# JOURNAL OF COASTAL AND HYDRAULIC STRUCTURES

Review and rebuttal of the paper

## Experimental study on a breaking-enforcing floating breakwater

Joep van der Zanden, Arne van der Hout, William Otto, Floor Spaargaren, Brenda Walles, and Jaap de Wilde

Figure R1: Results of motion decay tests in surge (left) and pitch (right) directions: measured (blue solid) and decay fit (orange dashed).

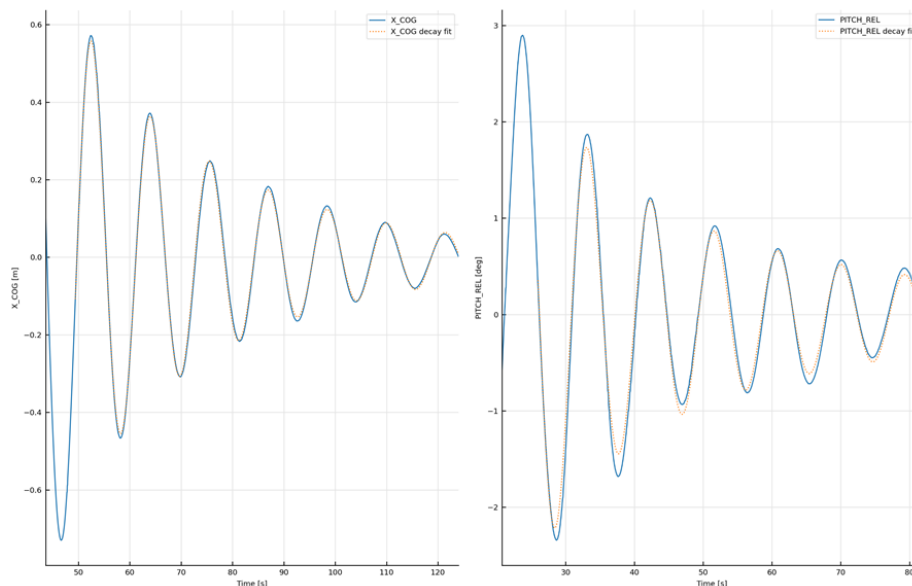
- It will be nice if you can add the decay curves performed for the calculation of the natural frequencies.

Figure R1 below presents the measured motions during the decay tests that were used to establish the damping values in Table 3 of the manuscript. A decay function that assumes linear and quadratic damping contributions was fitted through the measured motions based on a least square fitting approach. Good agreement between the decay fit and the measured motion is observed, which justifies the adopted approach.

We aim to restrict the paper to the key findings (figures and tables) of the study. For brevity, we decided not to include these decay fits in the manuscript.

Figure R2: measured and calculated motion RAOs in surge (left), heave (center), and pitch (right) directions. Distinction is made between calculations for a single floater (solid gray line) and for 3 floaters (black dashed line).

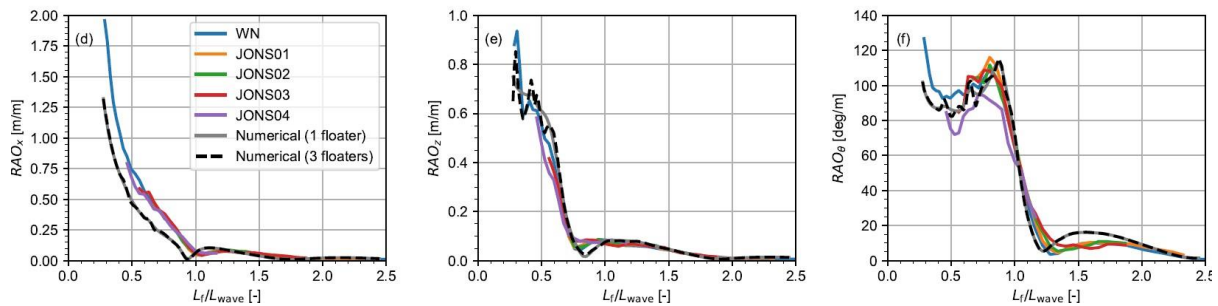
- The authors used three models and instrumented only the one. This should be emphasized in the paper. the possible hydrodynamic interaction between the three models should be numerically reported. Did you perform tests only with one model? (If yes, please provide the data and compare with the already presented data).

We agree that the hydrodynamic interaction between the three models has implications for the results. Unfortunately, no tests were performed with only one model in the basin. We therefore analysed the hydrodynamic interactions numerically through wave diffraction calculations involving a single floater and involving three floaters (copying the basin set-up).

Figure R2 presents the measured and calculated motion RAOs. The solid gray and dashed black lines mark the numerical calculations for a single floater and a 3-body numerical set-up, respectively. These two approaches result in generally similar motion RAOs. Only in heave direction, for low wave frequencies ( $L_f/L_{wave} < 0.6$ ), clear differences are observed between the both numerical approaches. The mores spiky behaviour for the 3-body calculations relates to the hydrodynamic interaction between models. Note that this behaviour is also observed in the experiments (see blue line in center panel).

*Figure R4: Measured vertical accelerations at four corners of the floater during a test in moored set-up. Note that the presented values correspond to a prototype scale 1:15.*

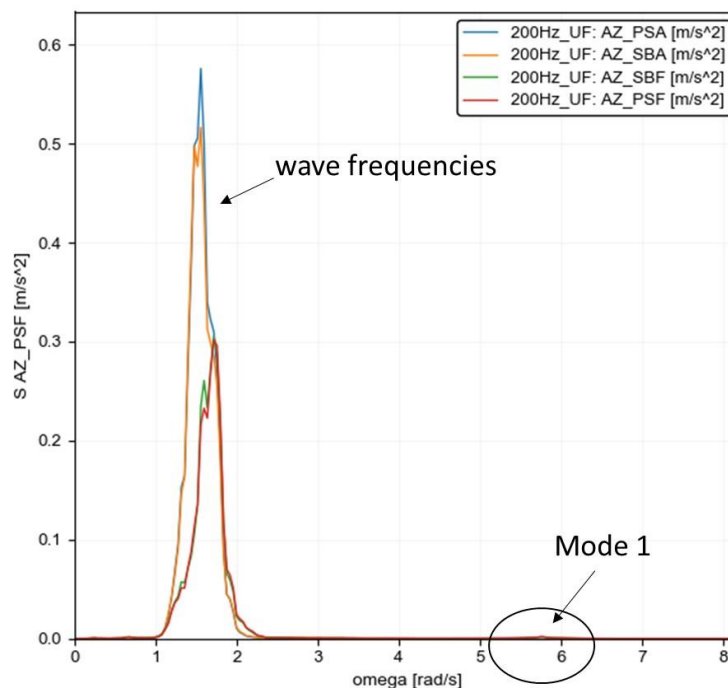
- The authors should check the hydroelasticity of the model (was the model rigid enough during tests or the floater had oscillations due to their eigenmodes). Authors should provide explanations on this and calculations related (dry and wet) eigenvalues.

The measured frequency corresponding to the first bending mode of the floater was 3.6 Hz at model scale (underwater). In order to check whether the natural frequency affects the motion response, the measured accelerations during the tests in waves were explored in more detail. Figure R4 presents the measured accelerations. It follows that the variance in accelerations is dominated by the wave frequency excitation and response (97.5% of the variance) while the energy at the first bending mode is minor (2.5% of the total variance in acceleration).

The revised manuscript includes a better explanation of the material properties and a concise paragraph on the floater’s natural frequency and its implication for the test results (Section 3.2.2).
